R610 St. Patricks Junction Improvement Scheme

Stage 1 Quality Audit

July 2026

Document reference: 100287864-MMD-REP-RSA-2026-030 | B

Figure 3.2: Proposed junction layout

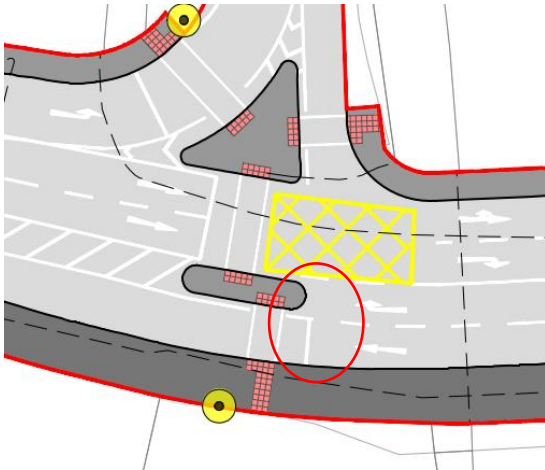
Location: Rochestown Road / N28 on-slip.

Summary: Right turning vehicles may believe they are uncontrolled and turn at the same time as eastbound traffic potentially leading to turning related collisions.

A stop line has been provided for westbound traffic on Rochestown Road, however right turning traffic is to pass in front of the traffic island. The provision of a controlled pedestrian crossing on the N28 on-slip indicates that the Rochestown Road right turn lane will be required to be signal controlled. However, the presence of the traffic island, potential positioning of traffic signals and lack of a stop line may mislead right turning motorists into believing they are not controlled. Vehicles turning right uncontrolled against eastbound traffic could result in vehicles turning across the path of ahead traffic increasing the risk of collisions. In addition, vehicles may fail to stop for the pedestrian crossing leading to an increased risk of collisions with crossing pedestrians.

Modify the signal-controlled crossing arrangement and associated traffic signal equipment and Stop lines so that the highway arrangement and signal control is clear to all users.

Figure 3.3: Proposed markings within the junction.

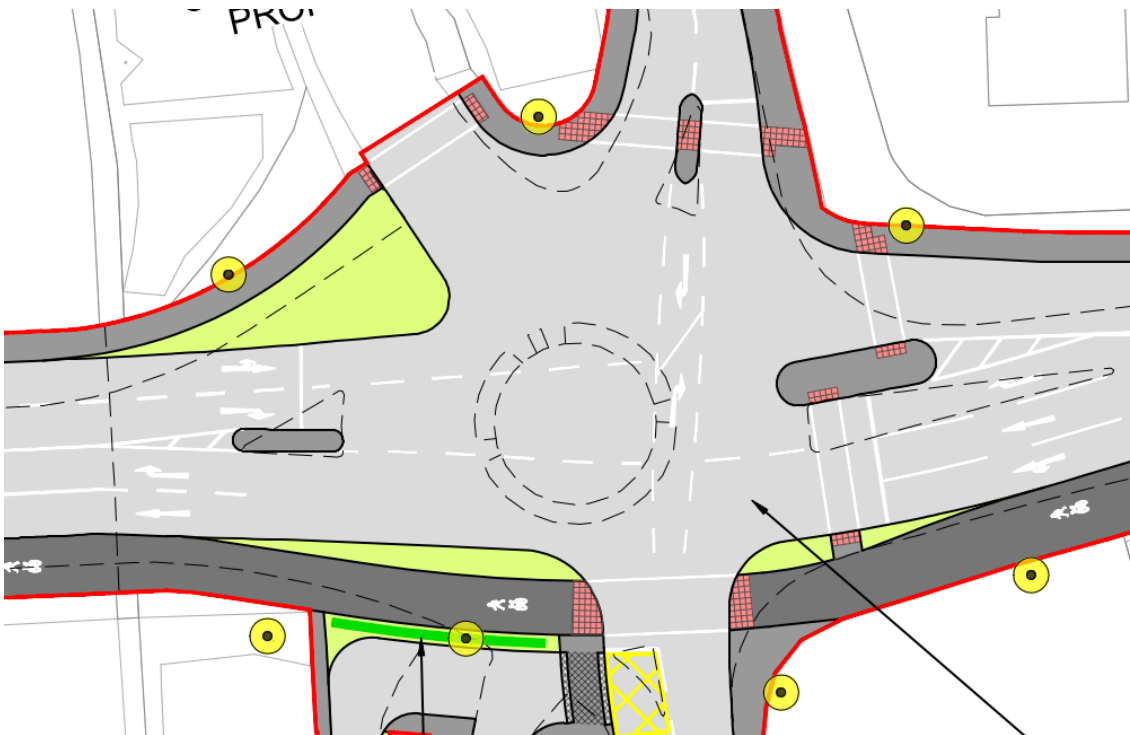
Location: Rochestown Road / N28 off-slip / Woodbrook / Mount Ovel.

Summary: A lack of clear markings for right turn manoeuvres increases the risk of turning related collisions at the junction.

A number of issues have been identified with the markings within the Rochestown Road, N28 off-slip, Woodbrook and Mount Ovel Junction which could lead to turning related collisions.

- Right turn lanes have been marked out for drivers turning from Woodbrook and Mount Ovel, however these are minor arms with low traffic flows. The markings also extend through the Rochestown Road westbound carriageway and therefore the junction layout may not be clear for other motorists using this junction.
- The right turn lane from Woodbrook guides right turning motorists towards the stop line for eastbound traffic on Rochestown Road.
- No right turn arrow(s) has been shown within the wide right turn lane for Rochestown Road traffic and with the other markings it may not be clear where traffic, particularly from the east, is to wait and turn.

Modify the right turn lanes so that the highway layout is clearly understandable to road users.

Figure 3.4: Proposed pedestrian crossing layout.

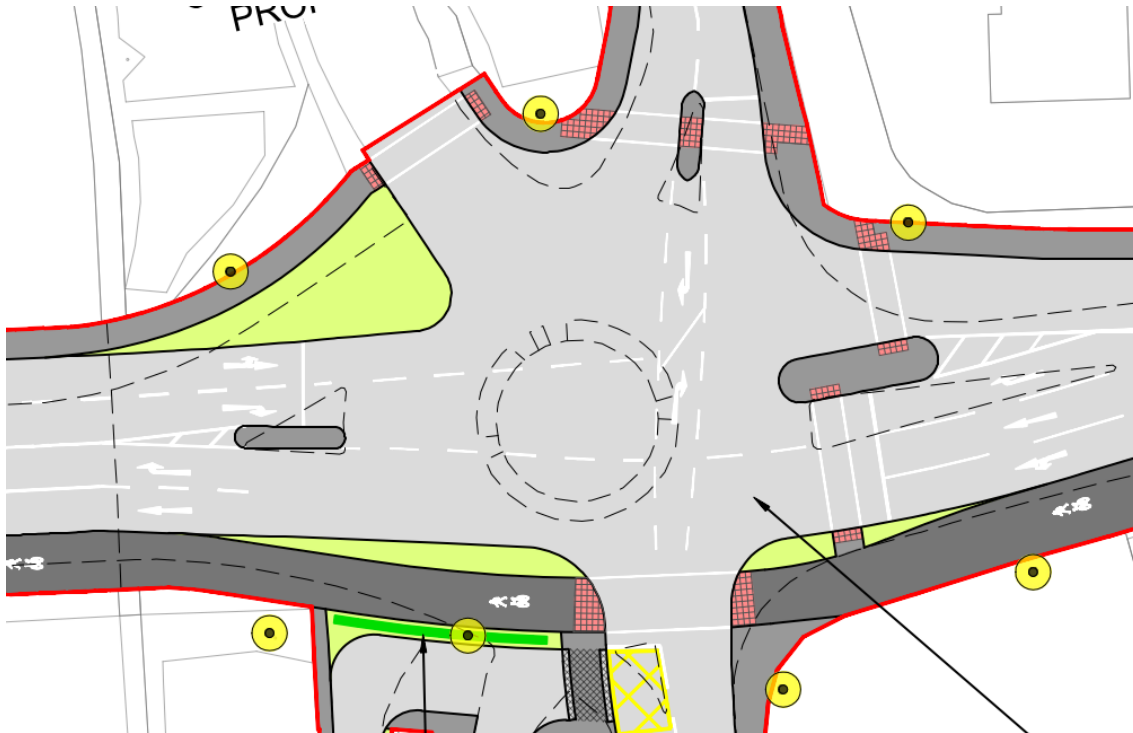
Location: Rochestown Road / Woodbrook / Mount Ovel junction.

Summary: Incorrect tactile paving may mis-lead sight impaired pedestrians increasing their vulnerability to being struck.

Controlled crossings are proposed over Westbrook, Rochestown Road and Mount Ovel. The tactile paving however is shown in multiple places without the stem which indicates to blind and sight impaired pedestrians that it is a controlled crossing. The lack of a stem may mislead users who may believe it to be an uncontrolled crossing, increasing their vulnerability to being struck by passing motorists.

Provide the correct tactile paving in line with relevant guidelines to reflect they are controlled crossings.

Figure 3.5: Proposed layout at Brookfield.

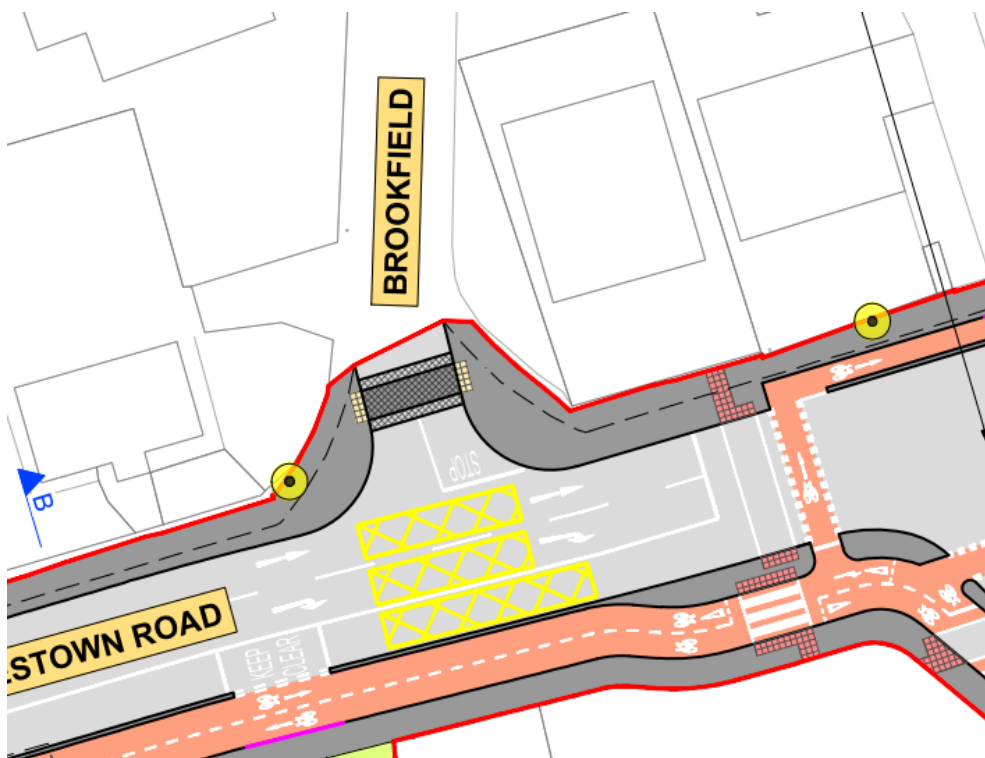
Location: Brookfield / Rochestown Road.

Summary: Lack of cycle provision for cyclists on the northern side of Rochestown Road to access the cycle track may lead to use of the pedestrian or unidirectional cycle crossing potentially resulting in conflict.

Should cyclists from Brookfield on the northern side of Rochestown Road wish to join the segregated cycle track on the southern side of Rochestown Road, they will be required to cross three lanes of traffic and be vulnerable to colliding with motorists. Alternatively, they may use the signalised pedestrian or unidirectional cycle crossing at Clarkes Hill and be at risk of colliding with pedestrians or cyclists.

Provide appropriate links between the northern and southern sides of Rochestown Road, this may involve providing a bi-directional cycle track across Rochestown Road.

Figure 3.6: Proposed cycle track layout at Clarkes Hill.

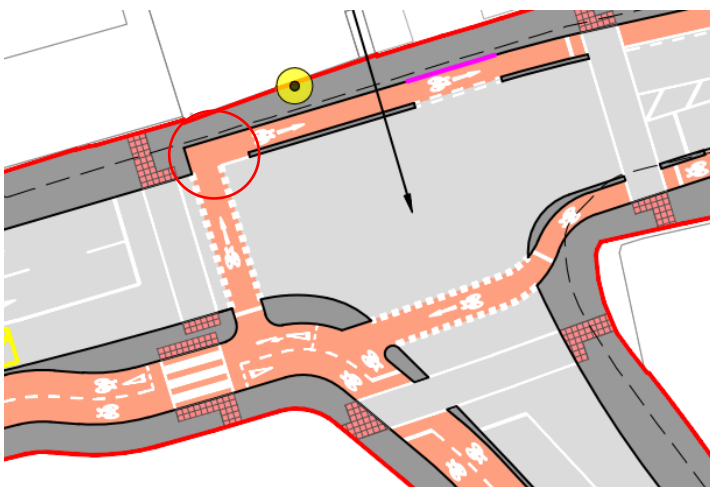
Location: Rochestown Road / Clarkes Hill northern arm.

Summary: Sharp turn for cyclists may result in the kerb being clipped or overridden leading to falls from bikes.

Cyclists from the southern side of Rochestown Road crossing to the northern side and heading east are expected to make a 90-degree turn. This sharp turn could be a difficult manoeuvre for some bikes to undertake which could result in the kerb being clipped or overridden. Should bikes strike the kerb, it increases the risk of cyclists being unseated which may result in cyclists falling from their bikes leading to personal injury.

Relax the angle of the cycle track so that it is more gentle and easier for cyclists to turn.

Figure 3.7: Proposed cycle track layout at Clarkes Hill.

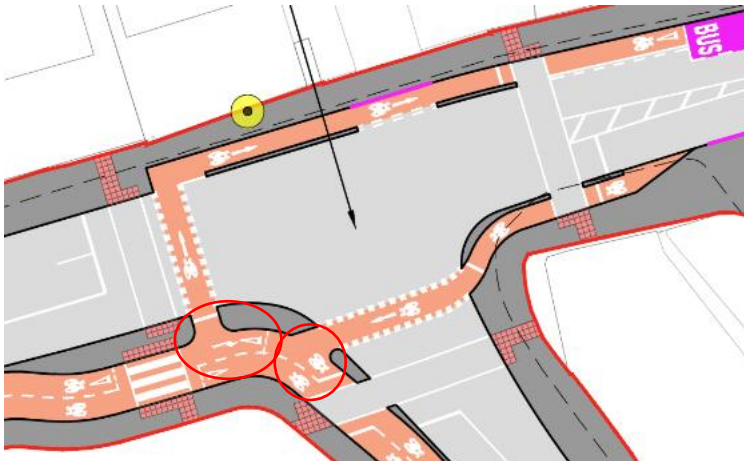
Location: Rochestown Road / Clarkes Hill northern arm.

Summary: Insufficient length of cycle track may lead to conflict with other cyclists.

The layout proposes locations where cyclists are to stop or give-way to other cyclists. The Road Safety Audit Team is concerned that cyclists waiting at these Stop and Give-way lines may block the path for other cyclists continuing on a different route potentially leading to conflict between cyclists.

Provide a sufficient length of cycle track for cyclists to wait without hindering other cyclists travelling in a different direction.

Figure 3.8: Proposed arrangement at Clarkes Hill.

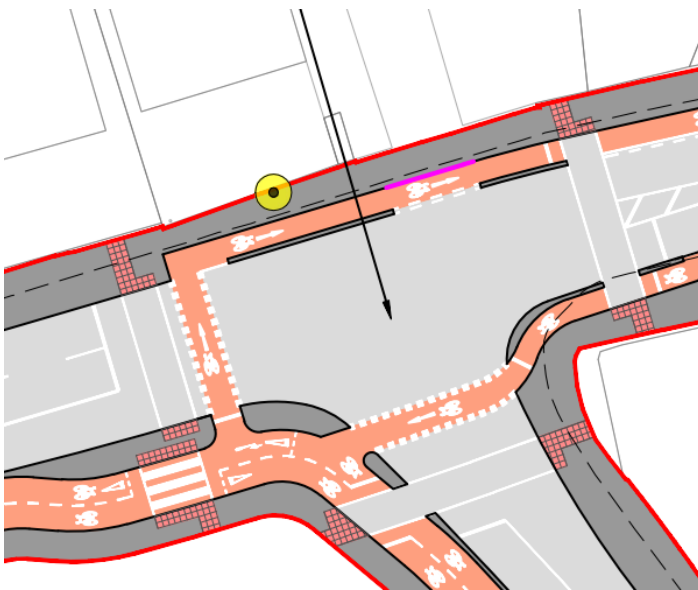
Location: Rochestown Road / Clarkes Hill northern arm.

Summary: Lack of control for those properties entering / exiting within the signalised junction could result in rear end shunt and turning related collisions.

Access to several properties is proposed within the signalised junction which do not appear to be controlled. The lack of control could result in motorists exiting the properties into the path of other traffic flows that have a green traffic signal which could result in conflict. Furthermore, through traffic may not expect vehicles to be slowing to turn within the junction leading to rear end shunt related collisions.

Provide signal control for those exiting from Clarkes Hill northern arm. The junction may need formalising and potentially narrowing

Figure 3.9: Proposed Crossings at Clarkes Hill.

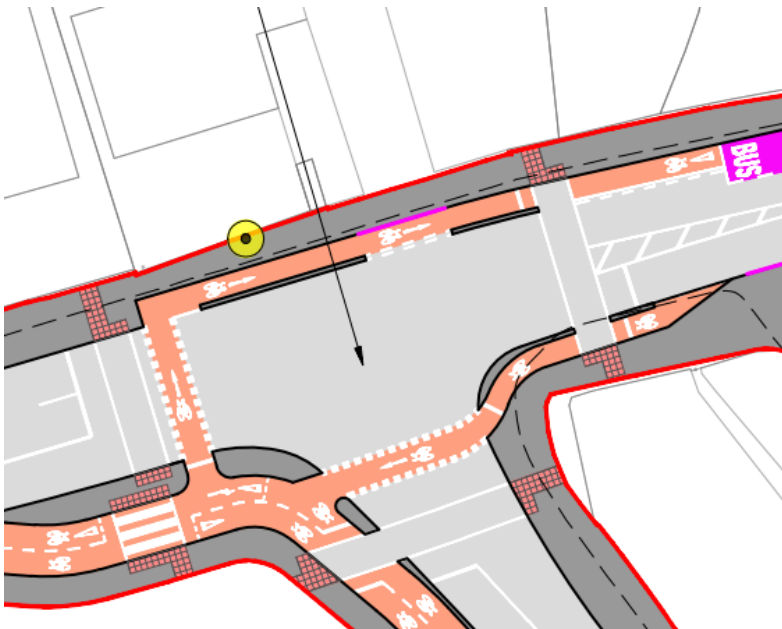
Location: Rochestown Road / Clarkes Hill.

Summary: Lack of appropriate green times for length of crossing may result in pedestrian collisions with motorists and cyclists.

The crossing widths, particularly on Rochestown Road eastern arm and Clarkes Hill are wide taking into account crossing of the cycle track. Should the pedestrian green times not be sufficient in length for pedestrians to complete their crossing movement, it could result in conflict with motorists or cyclists who may commence their movement before a pedestrian has completed their crossing.

Provide sufficient pedestrian green times to allow a pedestrian to fully cross the carriageway and cycle track prior to other signal stages receiving a green light.

Figure 3.13: Proposed layout at Riverside junction.

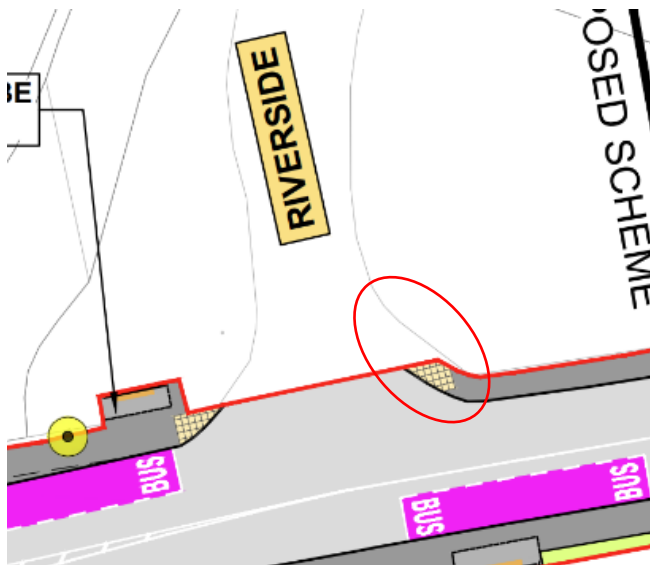
Location: Rochestown Road / Riverside.

Summary: Inappropriate tie in on Riverside could result in pedestrians walking within the carriageway at risk of conflict with motor vehicles.

The kerb alignment is to be amended, however it is not clear how the kerb is being modified and connecting with the existing provision on Riverside. Should the proposed footway fail to connect with the existing footway provision it could result in pedestrians being within the carriageway at risk of conflict with motorists.

Continue the footway from Rochestown Road into Riverside.

Figure 3.14: Proposed bus stop opposite Riverside.

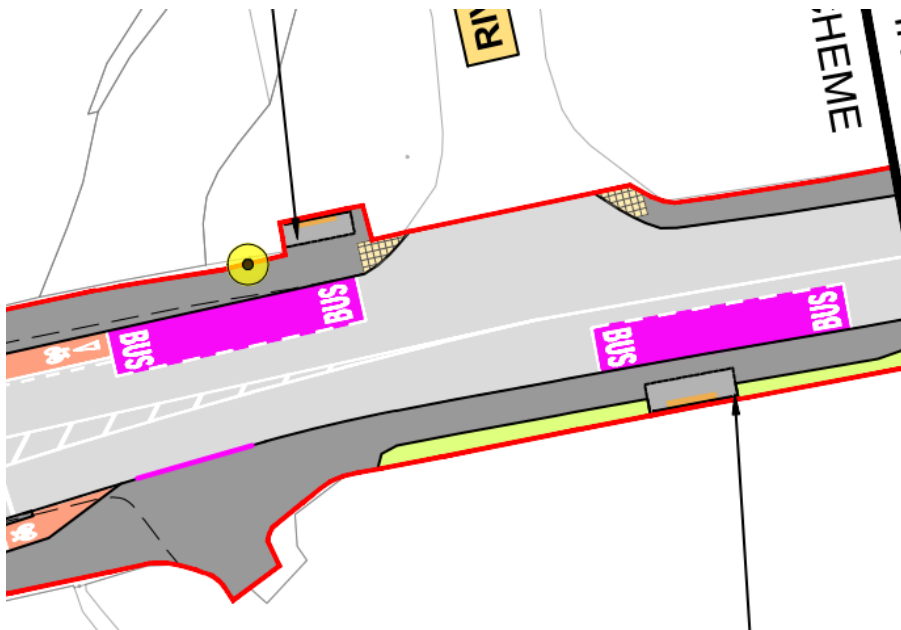
Location: Rochestown Road / Riverside.

Summary: Bus stop opposite junction may lead to vehicles overtaking a bus at the same time a vehicle exits Riverside leading to turning related collisions.

The bus stop on the southern side of Rochestown Road is proposed almost opposite Riverside. There is concern that a westbound vehicle on Rochestown Road may attempt to overtake a stationary bus at the same time a vehicle pulls out of Riverside, increasing the risk of turning related collisions.

Relocate the bus stop further away from the junction.
